# Klauke®

## Product Change Announcement

Klauke FMS L-Series cable lugs are now discontinued and will be replaced by the MS L-Series cable lugs.

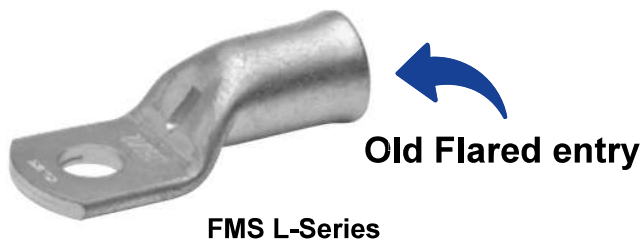
The two ranges are **identical** apart from the entry to the barrel. The FMS has a flared entry whereas the MS has a straight external barrel.

To ensure the easy entry of class 5 cables is maintained, an increased internal chamfer or "i-Flare" has been implemented on the new MS series.

- There is **NO CHANGE** to crimping dies or tooling. Existing tools and dies can be used.
- Neater finish after crimping (No raised diameter on flared section)
- Accepts larger variety of cable types
- Pricing remains the same as FMS
- Improved stock availability and shorter lead times
- Orders received for FMS will automatically convert to MS
